**Addendum #1
Clinton Central JR/SR High
Gym Renovation**

Date: 09/26/25
Project: Clinton Central JR/SR High Parking Lot Expansion
Project #: 24059
Pages: 1 of 3 (8-1/2x11) pages
Bid Dates: Tuesday, September 30th 2025 at 2:00 pm (prevailing local time)

Drawing Set Items:

DRAWING NO.
C1-1

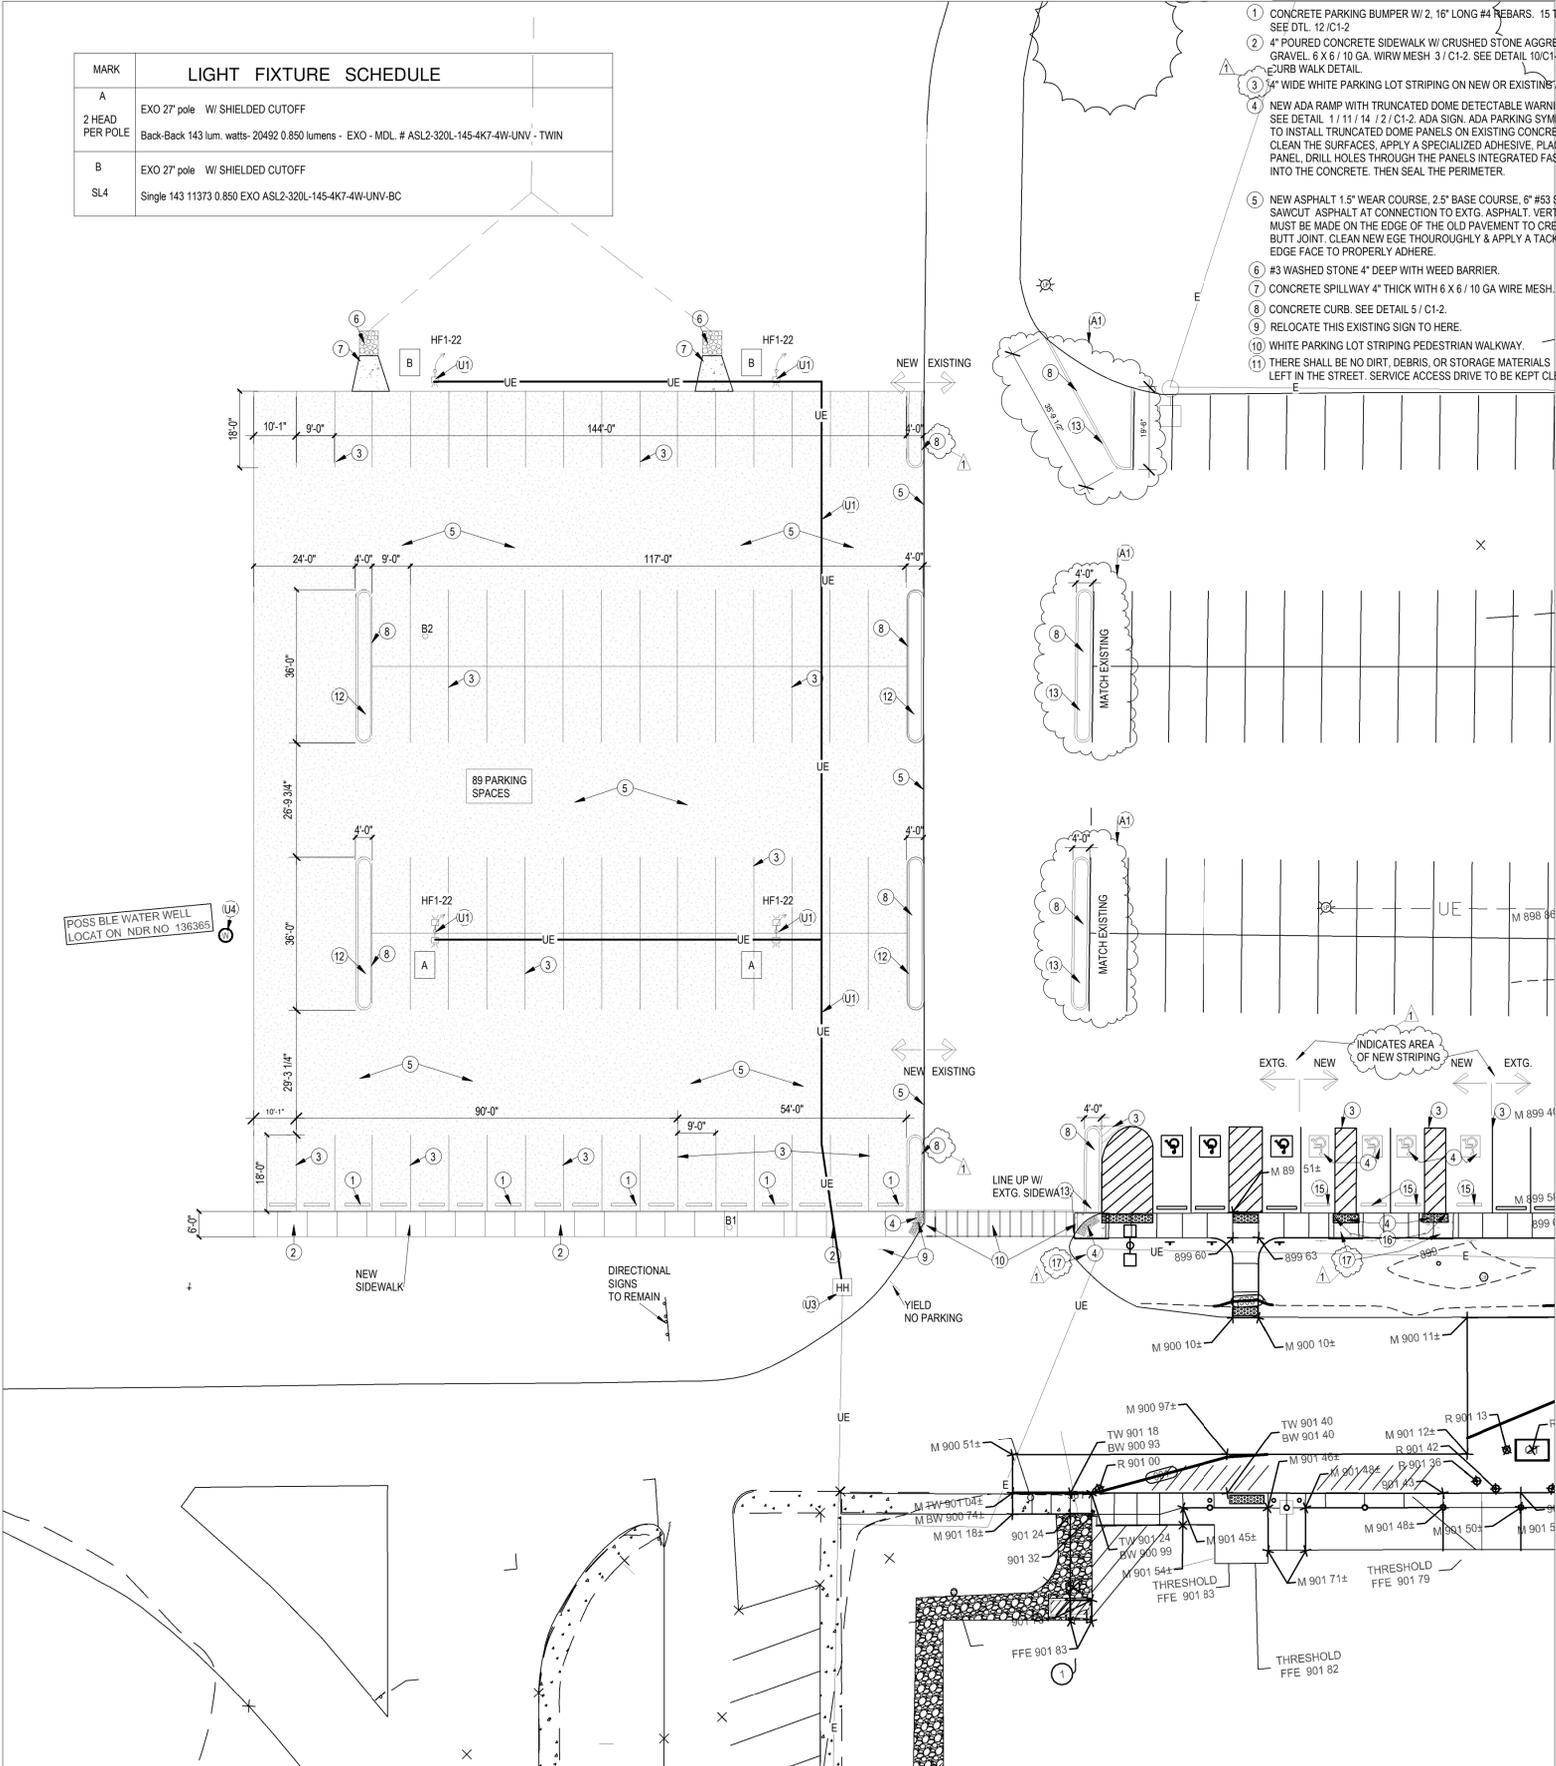
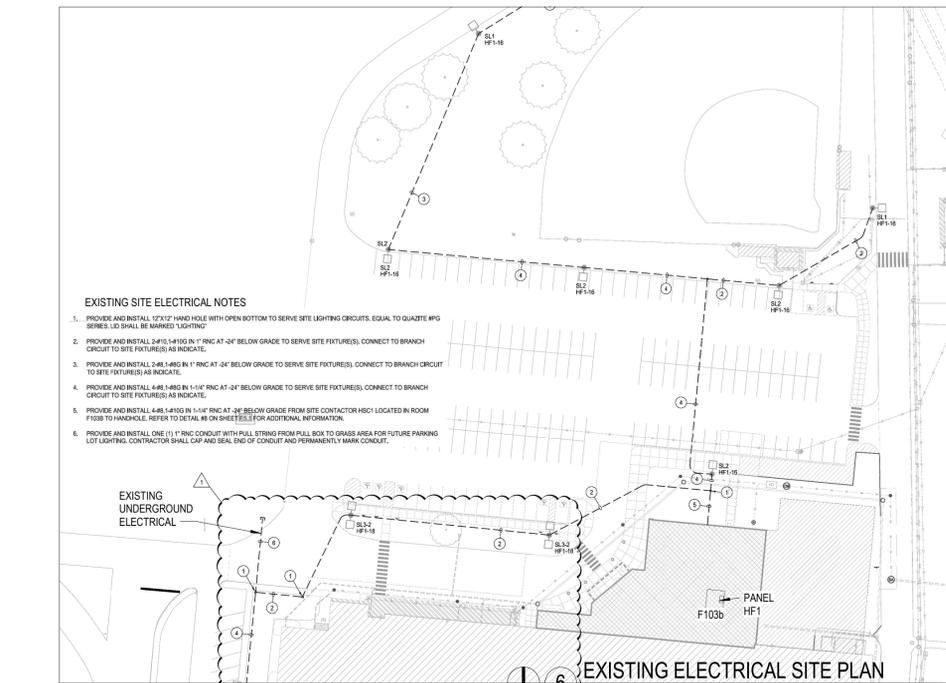
1. *The slanted curb detail included in this addendum is acceptable.*
2. *There is no work inside or along the extg. building.*
3. *Wire mesh as described will be required.*

4. *ADA truncated dome plates are acceptable. Provide shop drawing before any installation.*
5. *All utilities that were shown on existing surveys for this area of the project have been shown on the drawings. The site contractor will be required to hire an independent locating company of there choice for the existing utilities within the project area. Independent utility locating to be coordinated by the Site Contractor.*

6. *Added note #8 to the 2, new u shaped curbs, north and south of the project..See sheet C1-1*
7. *The new light poles need to match existing light poles exactly.*

8. *There is no new asphalt in that area of new striping existing parking lot. We are adding the new parking lot striping ADA spaces. The new identifies the new striping. See Sheet C1-1.*

9. *Added the handicap rumble dome to the end of the new sidewalk. See sheet C1-1.*
10. *The existing concrete where the new ADA rumble domes to be installed to be removed and poured back into place so the new rumble domes will adhere to the new concrete. See sheet C1-1. Same thickness and finish.*

DRAWING NAME
LANDSCAPE & EROSION CONTROL PLAN
 DRAWING NO. C4-1

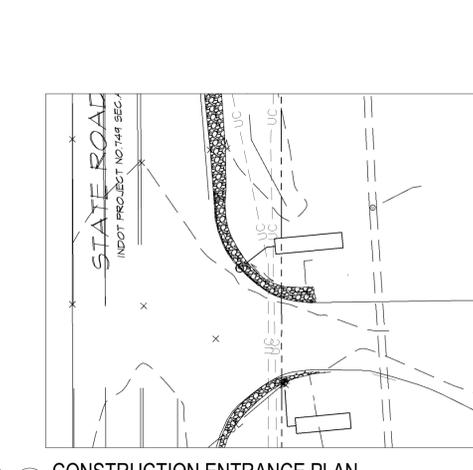
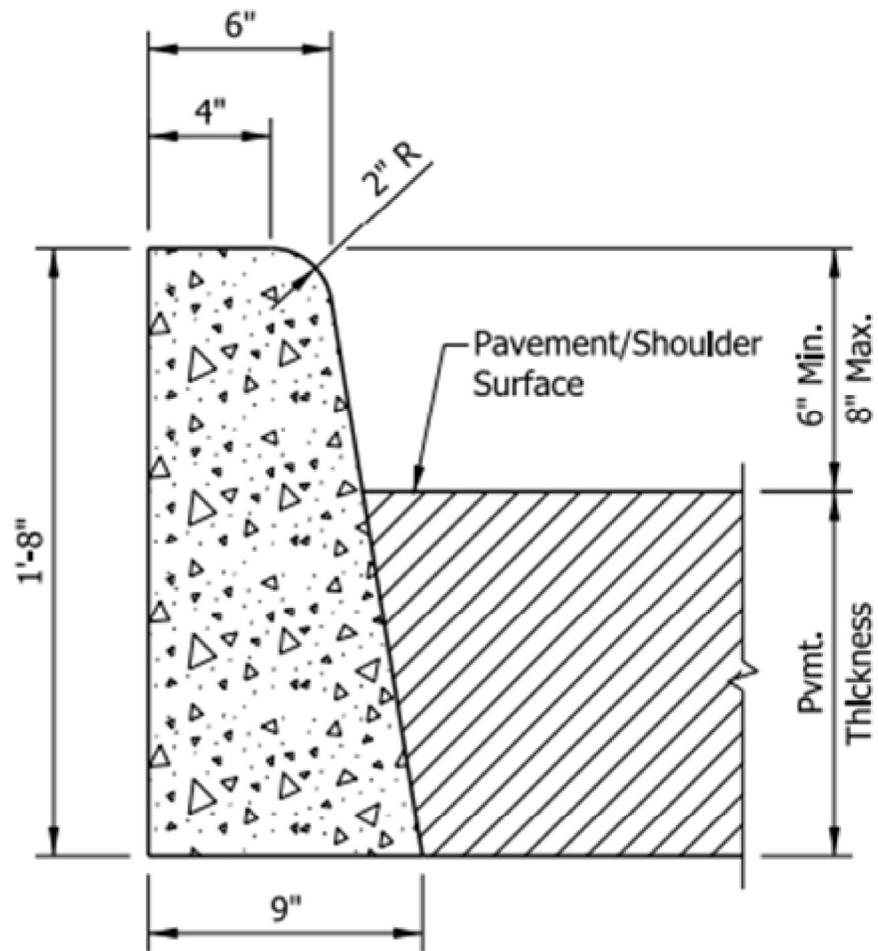
1. *-The entire landscape island is to be filled with the river rock with weed barrier underneath. See detail 5/ C1-2.*

2. *NOTE 2. ALL EXCESS DIRT, TOPSOIL TO BE ADDED OR REMOVED OFFSITE BY THE SITE CONTRACTOR. SITE CONTRACTOR TO DETERMINE AMOUNT OF SOIL, TOPSOIL TO BE BROUGHT ONTO THE SITE OR REMOVED. TO OBTAIN NEW SITE GRADING ELEVATIONS SHOWN. ALL EXCESS DIRT TO BE REMOVED OFFSITE.*
